**TO:** DEVELOPMENT REVIEW BOARD **DATE:** August 21, 2003  
**FROM:** CURRENT PLANNING SERVICES  
**SUBJECT:** CASE 47-DR-2003  
**REQUEST:** Approve site plan & elevations for a 112-room, 4-story hotel  
**PROJECT NAME:** Wingate Inn & Suites  
**LOCATION:** 14255 N 87th St

## **Stipulations for Case: Wingate Inn & Suites Case 47-DR-2003**

# DEAD-END PARKING AISLE DETAIL

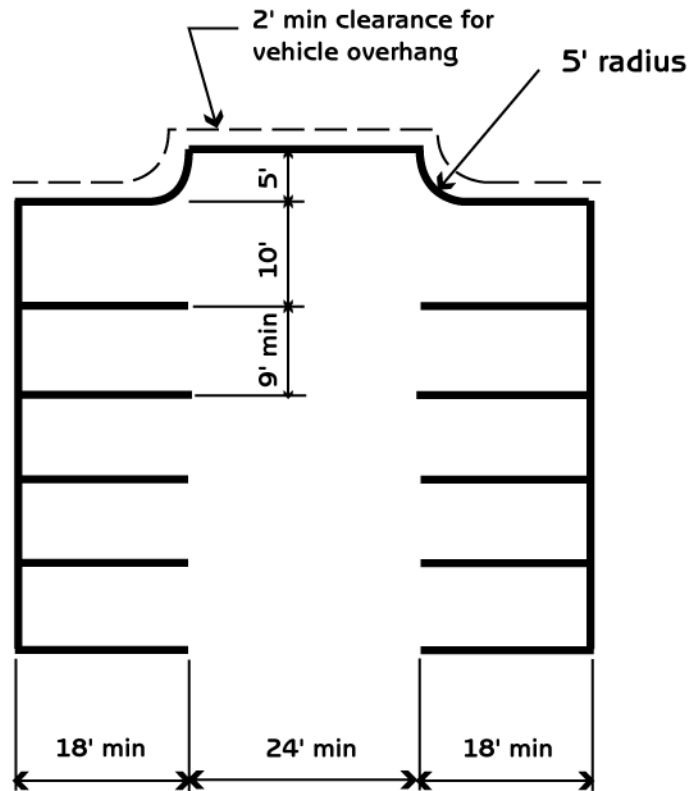
29. The developer shall provide a minimum parking-aisle width of 24 feet.
30. The developer shall provide internal circulation that accommodates emergency and service vehicles with an outside turning radius of 45 feet and inside turning radius of 25 feet.
31. The developer shall design the dead-end parking aisles in general conformance with the attached detail.

1. Maximum dead-end parking aisle length is 150 feet.
2. If the length exceeds 150 feet, a turn-around shall be provided for emergency vehicles.
3. No refuse enclosures are permitted on a dead-end aisle.
